CITY OF PORTLAND, MAINE
ZONING BOARD OF APPEALS

25 Aspen Drive

February 23, 1988

BUILDING PERMIT REPORT

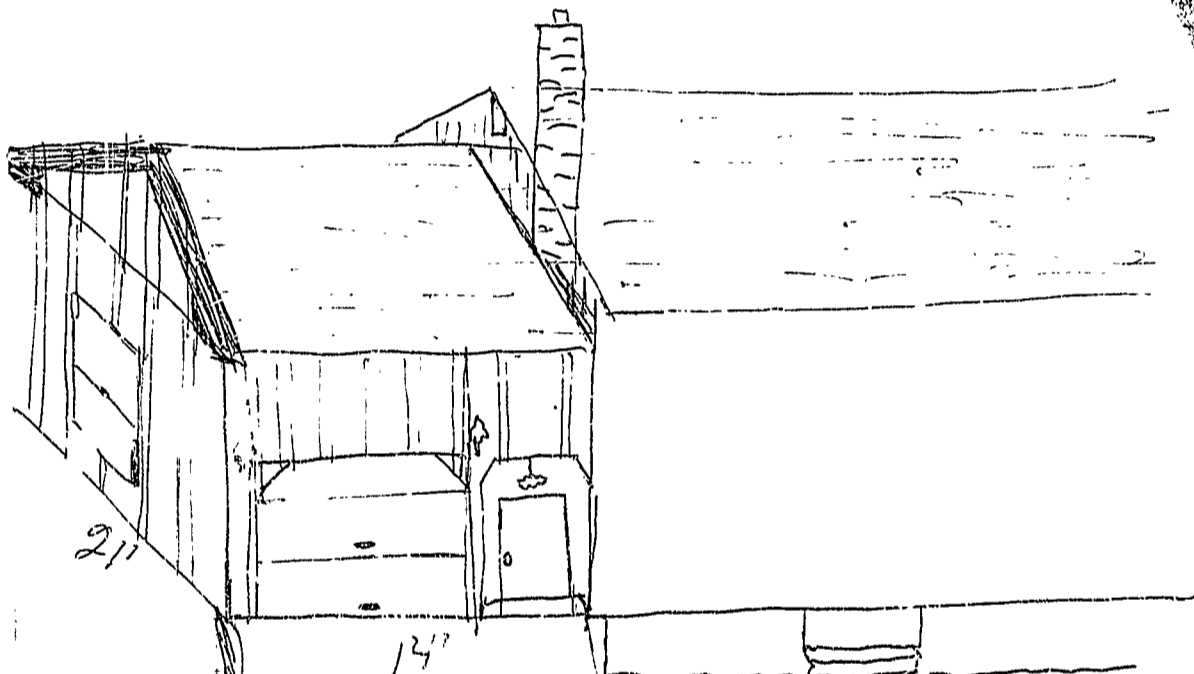
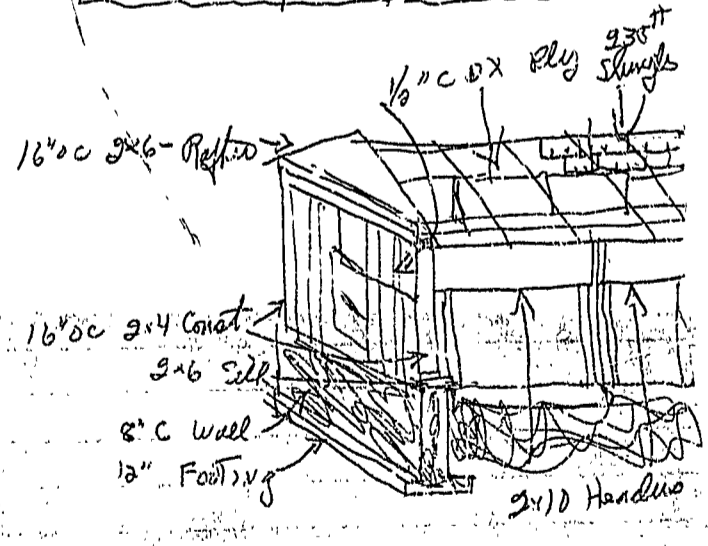
DATE: 15/mar/88
ADDRESS: 25 ASPEN DR.
REASON FOR PERMIT: ONE CAR ATTACHED GARAGE.
BUILDING OWNER: DAVID BEAN
CONTRACTOR: LOGAN DYMON
PERMIT APPLICANT _____
APPROVED: *6 DENIED

- *6.) Private garages located beneath rooms in buildings of Use Groups R-1, R-2, R-3 or I-1 shall have walls, partitions, floors and ceilings separating the garage space from the adjacent interior spaces constructed of not less than 1-hour fire-resistance rating. Attached private garages shall be completely separated from the adjacent interior spaces and the attic area by means of 1/2-inch gypsum board or equivalent applied to the garage side. The sills of all door openings between the garage and adjacent interior spaces shall be raised not less than 4 inches (102 mm) above the garage floor. The door opening protectives shall be 1 3/4-inch solid core wood doors or approved equivalent.
